AGENDA CITY OF SALIDA PLANNING COMMISSION

1. Major Impact Review – River Ridge Major Subdivision - The request is for Major Impact Review of a Major Subdivision for River Ridge Subdivision consisting of 41 lots on 9.06 acres located on Scott Street, 500 feet north of CR 105 (Old Stage Road). The property is zoned R-3 and R-4.

PLANNING COMMISSION STAFF REPORT

RE: River Ridge Subdivision Plan review comments

SHEET NO. RIVER RIDGE SALIDA, CO 13 SEWER PLANS OF_{OF} SHTS. SEWER DETAILS PROJECT NO. **DETAILS** 18031

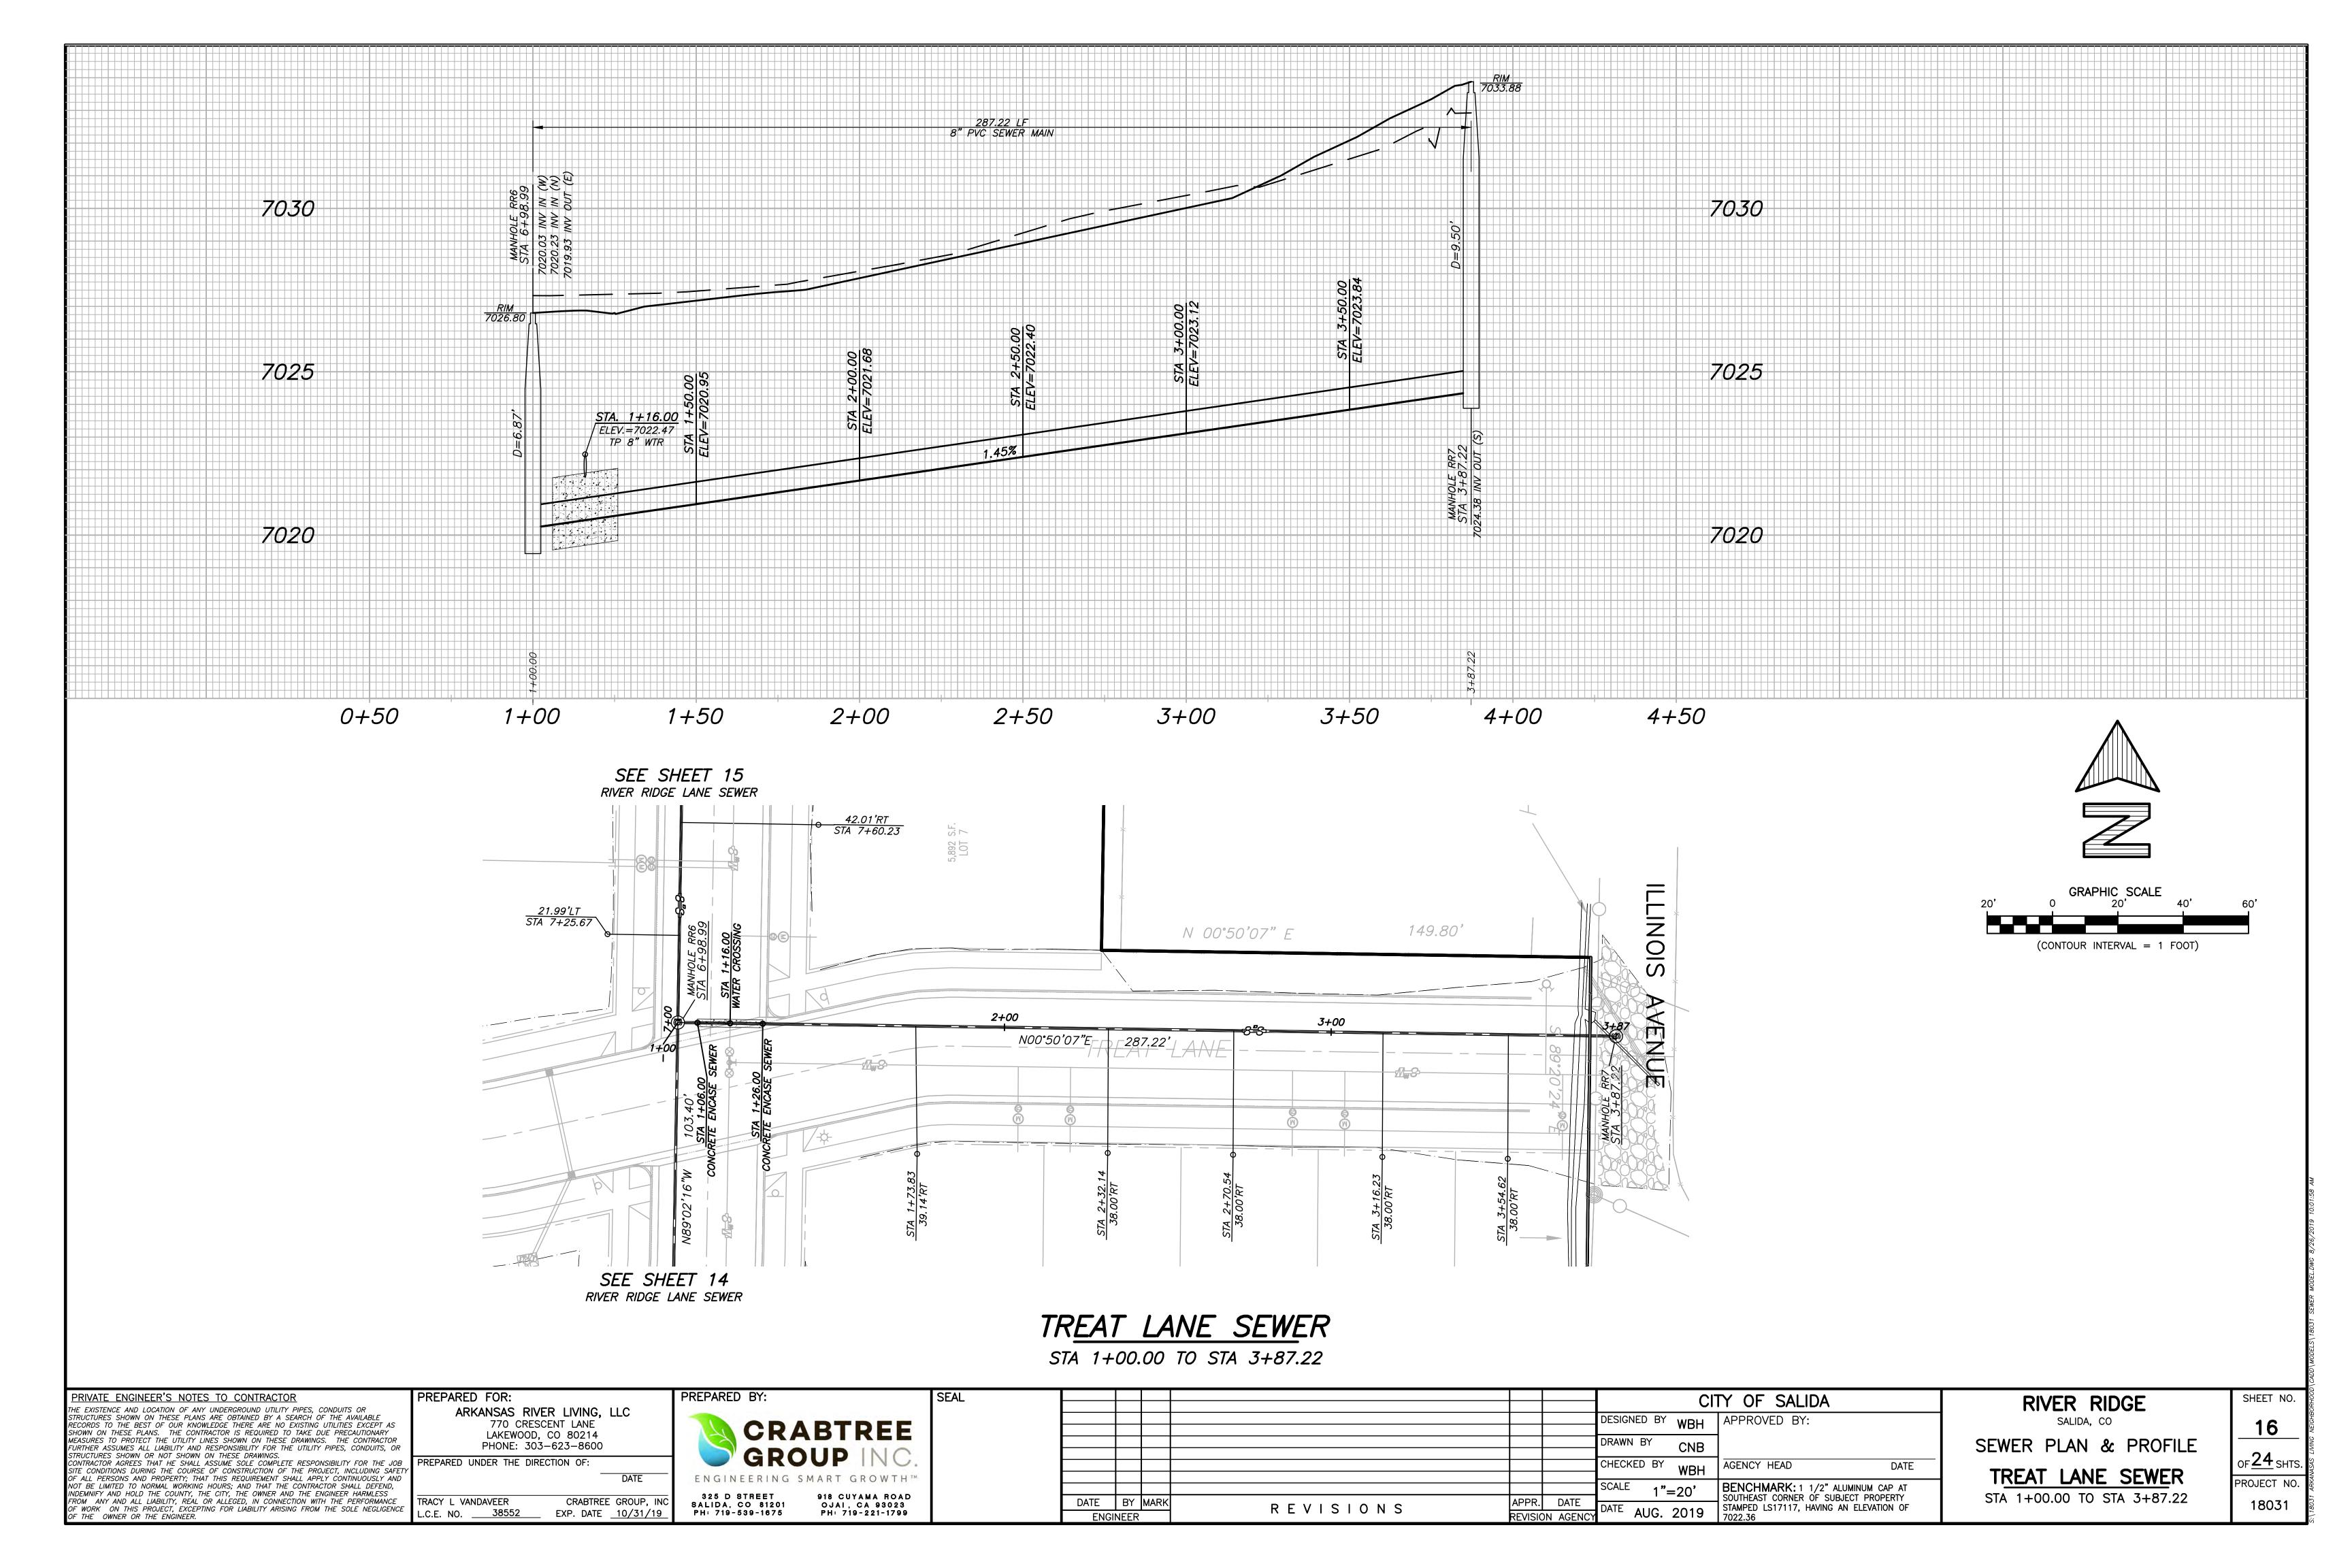
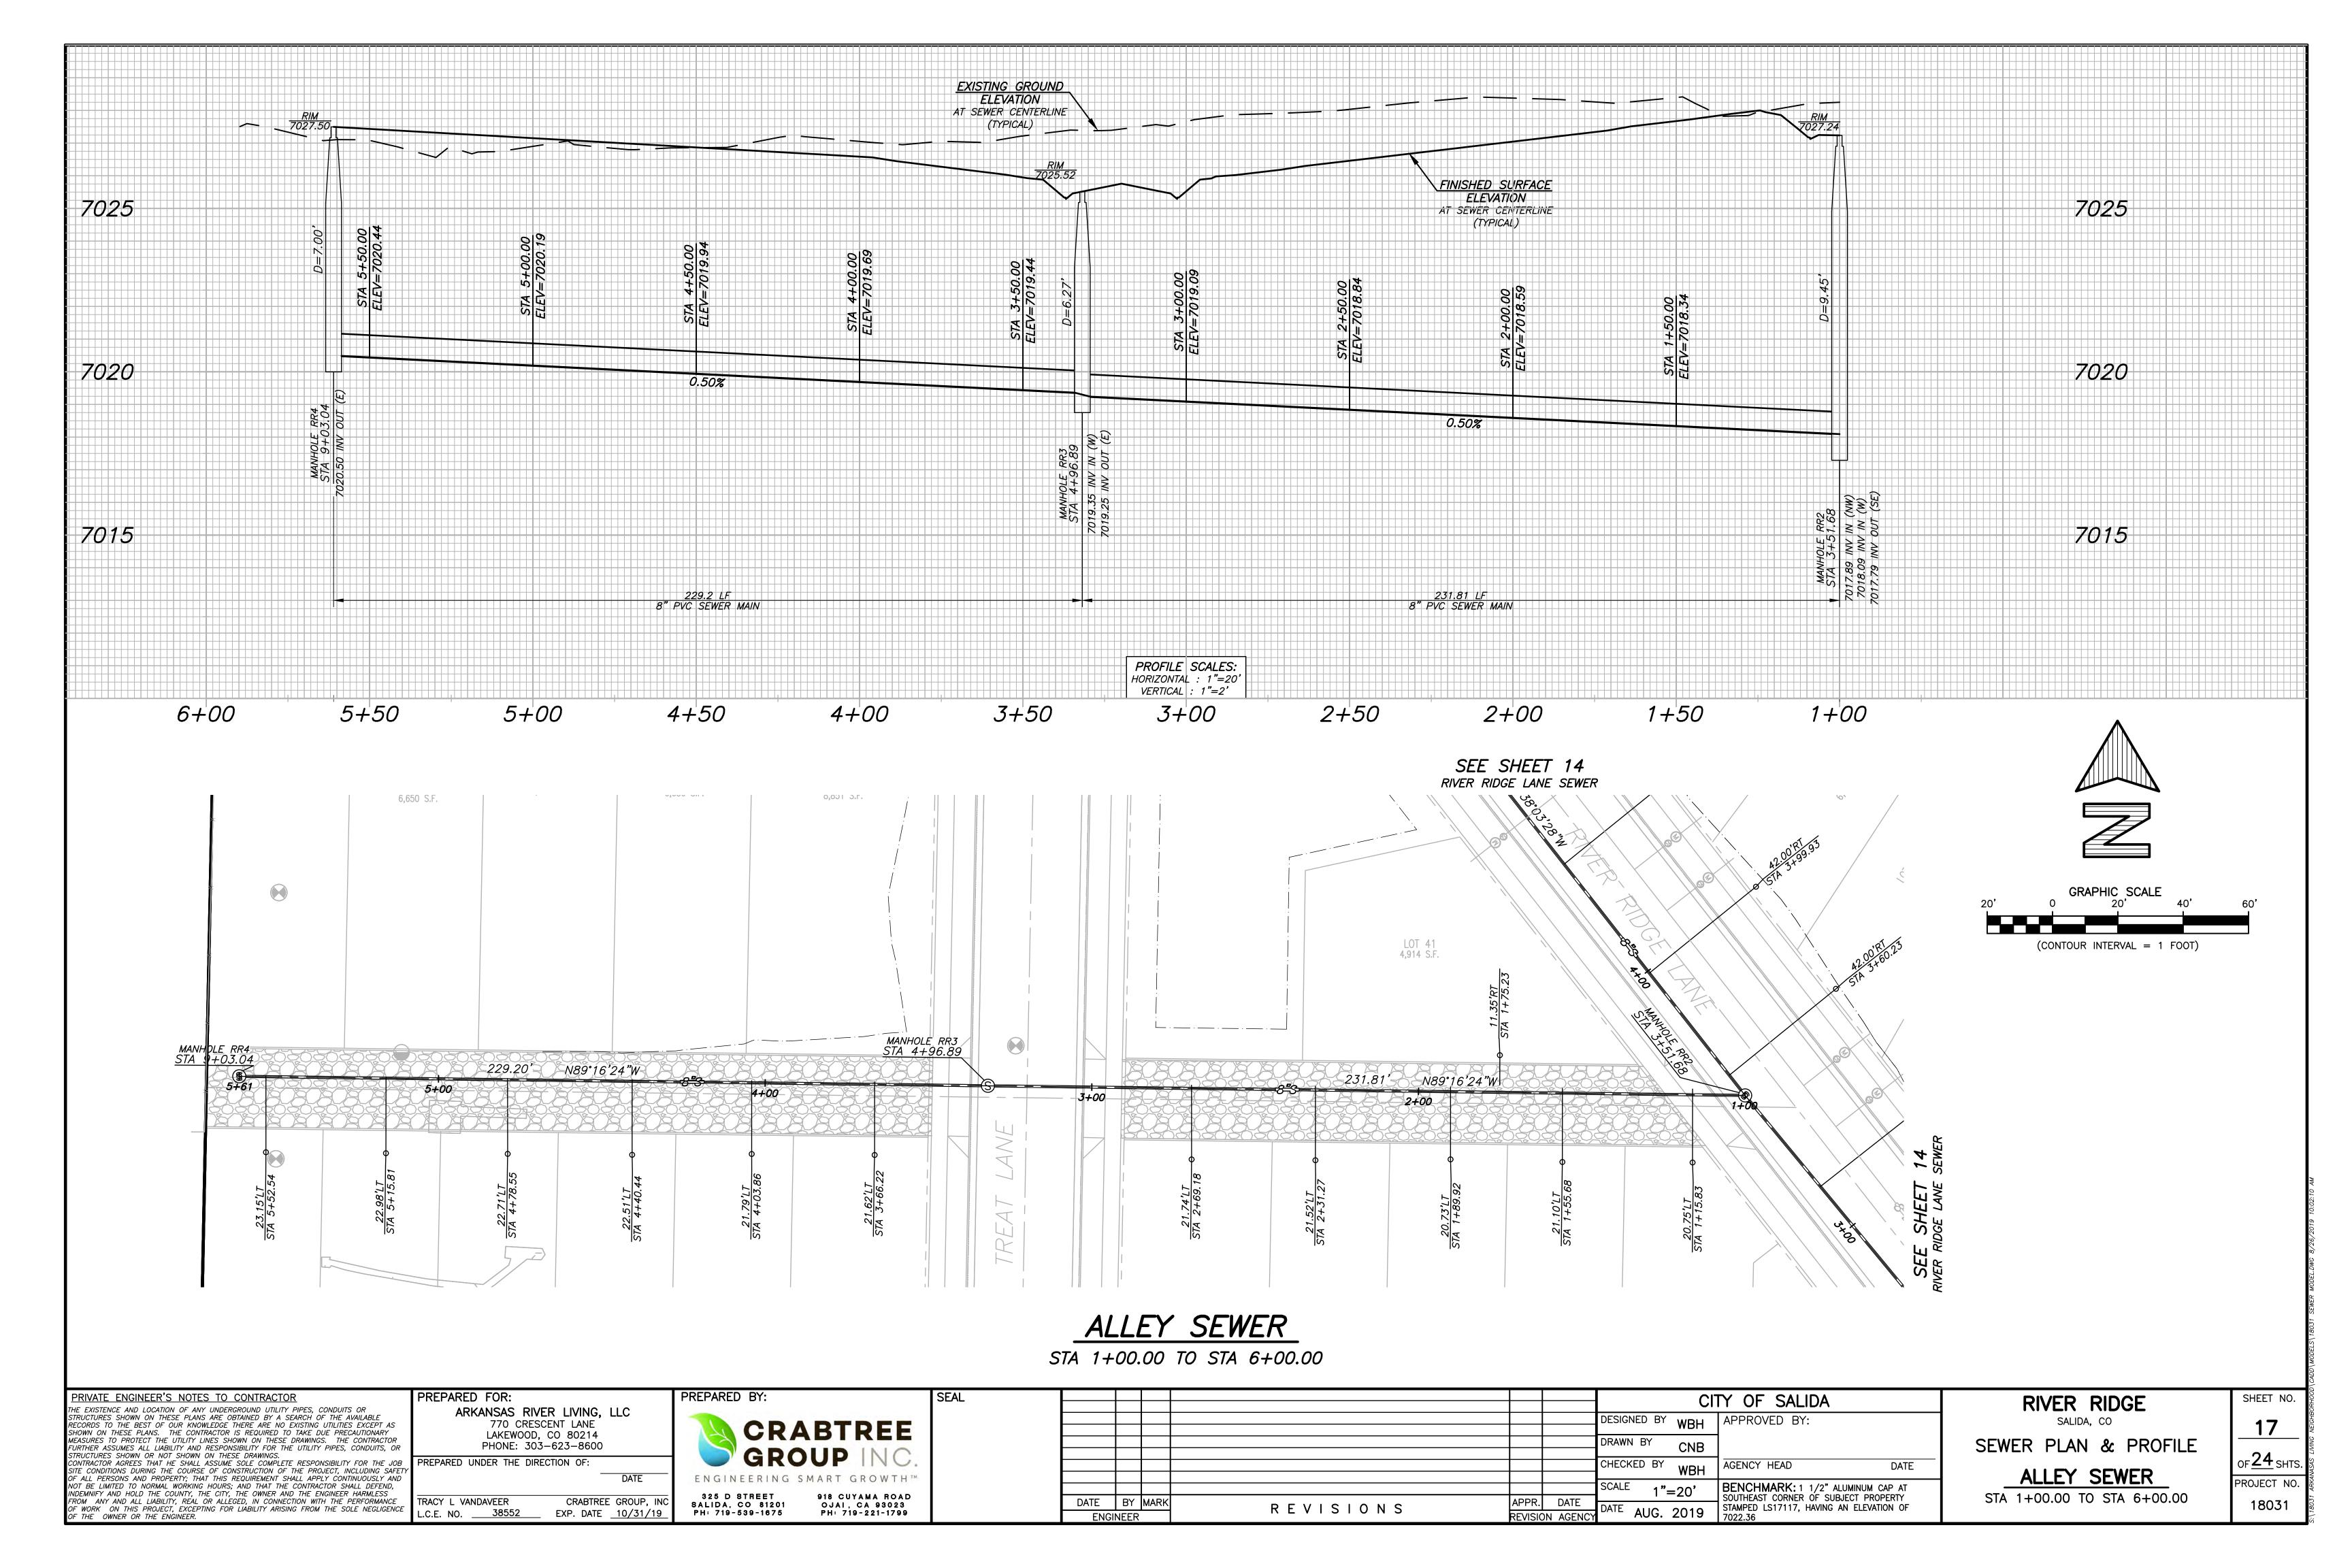
- 9. Sheet numbers on sewer index sheet need corrected.
- 10. Identify Tie-In Manhole as MH-17D. Note 'Core Drill Existing Manhole and Grout with Non-Shrink Grout.' (SH-14)

WATER COVER SHEET INDEX MAP. NOTES, DETAILS

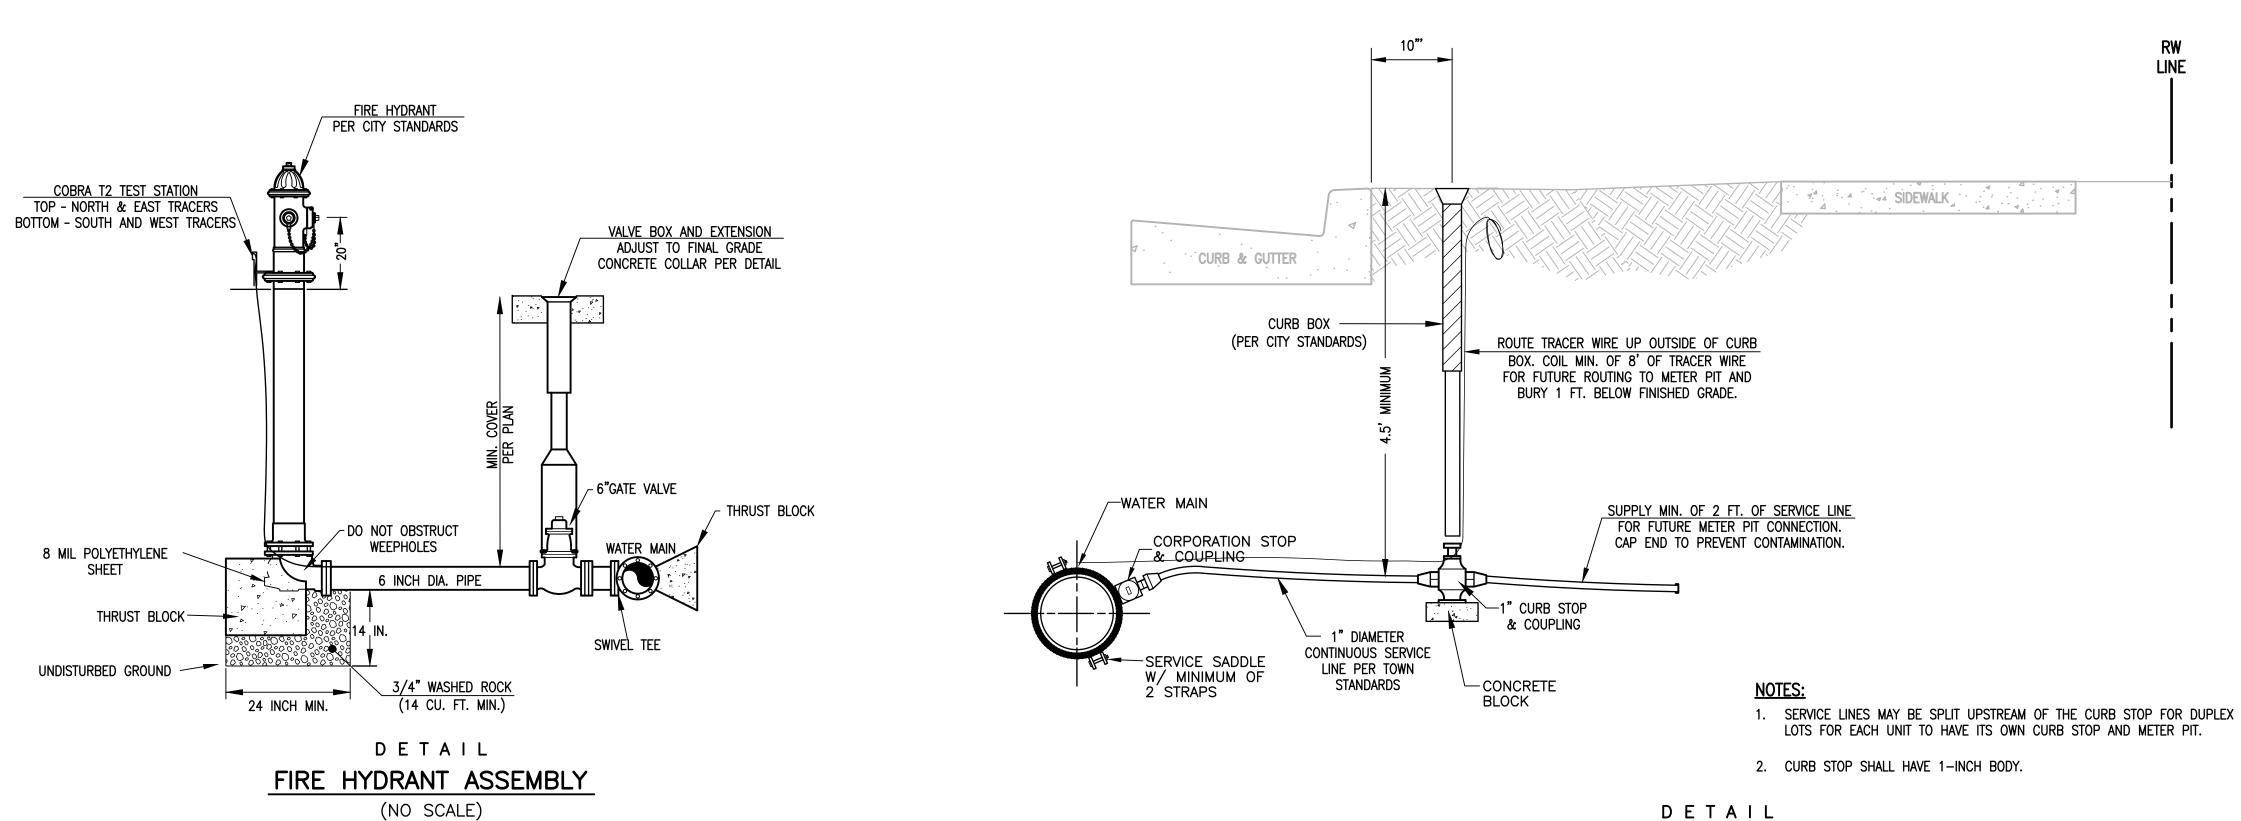
- 11. Identify existing hydrants and valves on the water cover sheet (SH-18).
- 12. Call-out street names and lot numbers on plan and profile sheets.
- 13. Water service line to be extended to beyond the property line (SH-19).
